Title - Sujet Victoria SAR Station Construction	
Solicitation No. - N° de l'invitation F1700-184521/A	Amendment No. - N° modif. 002
Client Reference No. - N° de référence du client	Date 2019-02-20
GETS Reference No. - N° de référence de SEAG PW-\$PWY-039-8541	
File No. - N° de dossier PWY-8-41217 (039)	CCC No./N° CCC - FMS No./N° VME
Solicitation Closes - L'invitation prend fin at - à 02:00 PM on - le 2019-03-01	
Time Zone Fuseau horaire Pacific Standard Time PST	
F.O.B. - F.A.B.	
Plant-Usine: <input type="checkbox"/> Destination: <input checked="" type="checkbox"/> Other-Autre: <input type="checkbox"/>	
Address Enquiries to: - Adresser toutes questions à: Park (PWY), Isabell	Buyer Id - Id de l'acheteur pwy039
Telephone No. - N° de téléphone (604) 365-0073 ()	FAX No. - N° de FAX (604) 775-9381
Destination - of Goods, Services, and Construction: Destination - des biens, services et construction: DFO - Search and Rescue Station - Victoria, BC

Amendment 002

1. Addendum #1; and,
2. A1.01 Site Plan

**VICTORIA SAR
 STATION**

Sheet: A1.01

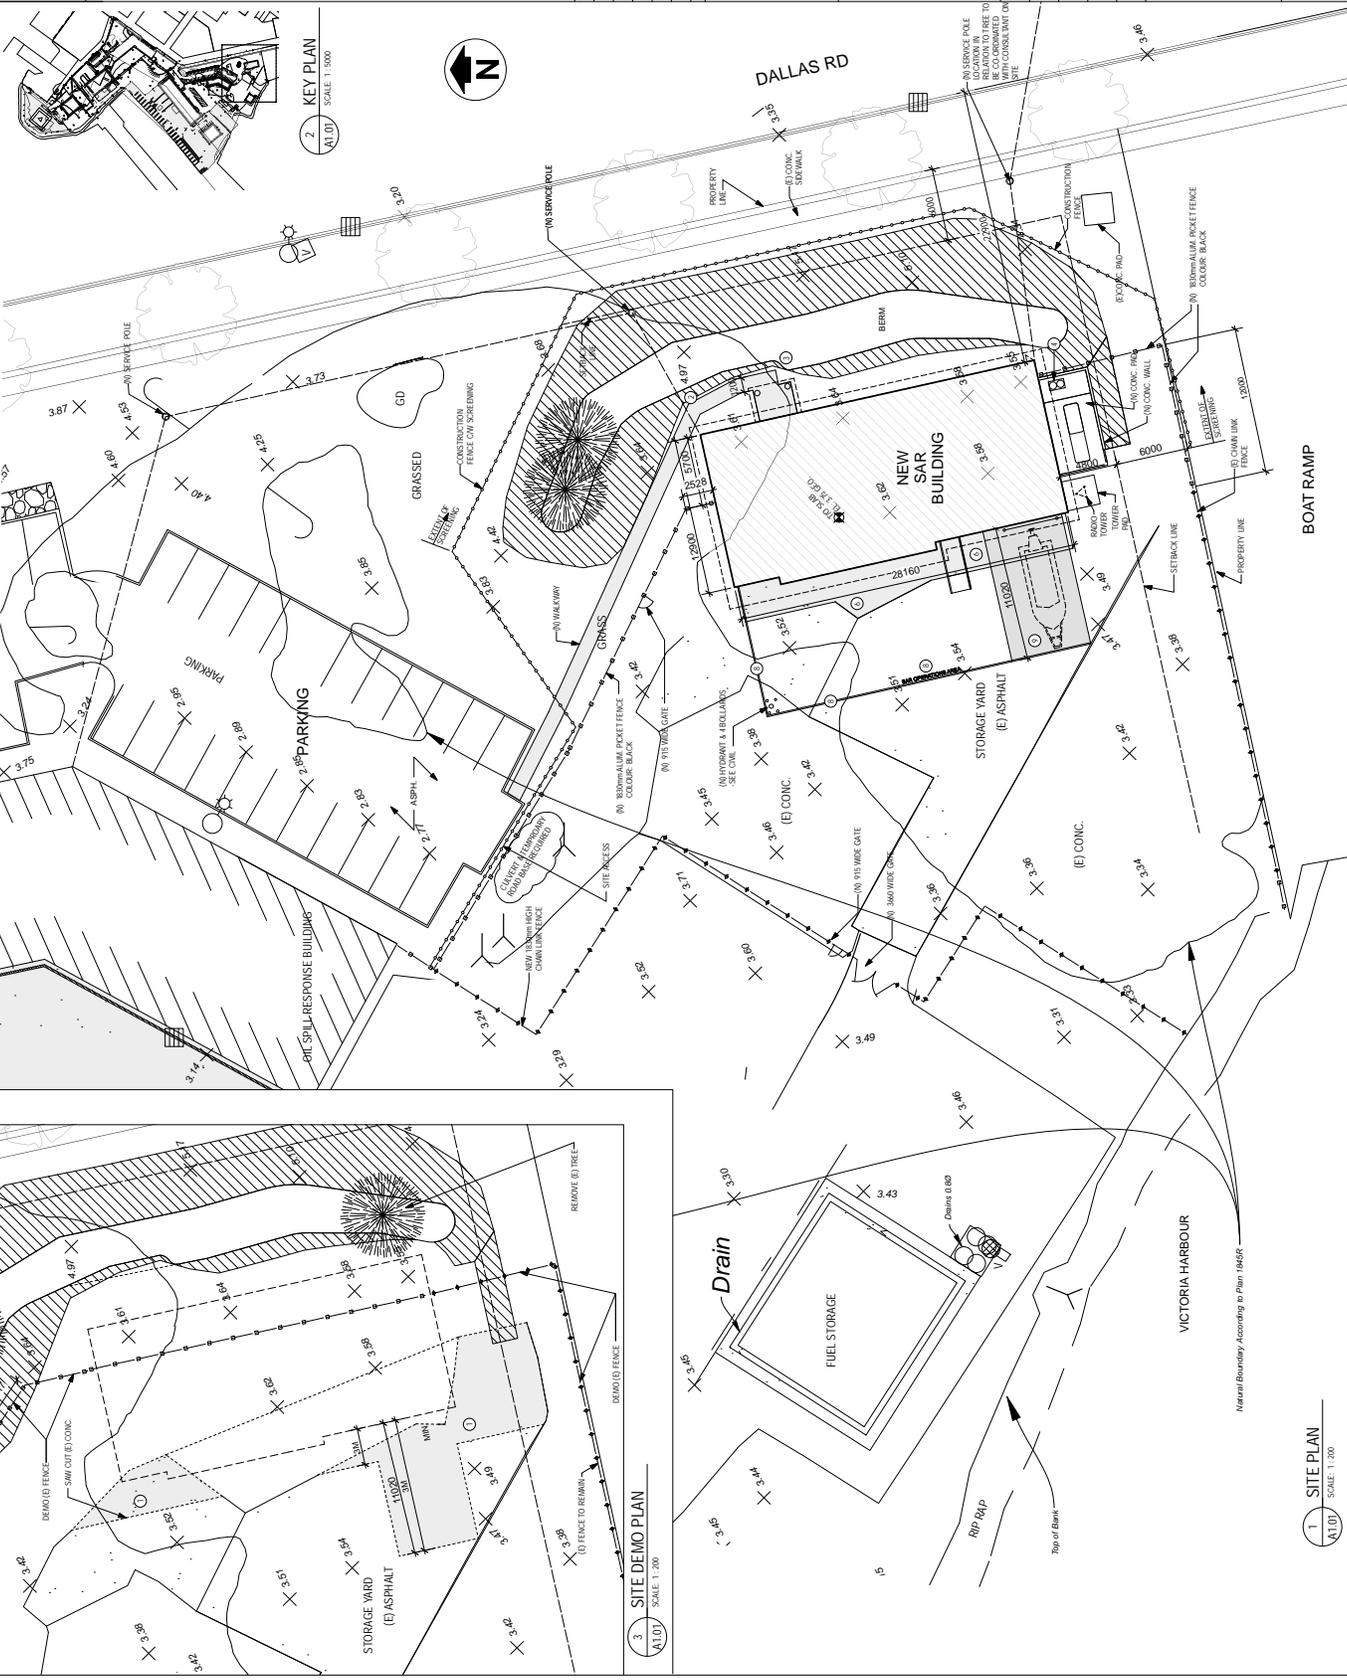
1. Drawing A1.01 (see attached)

Revised fence line and laydown area indicated on site plan.
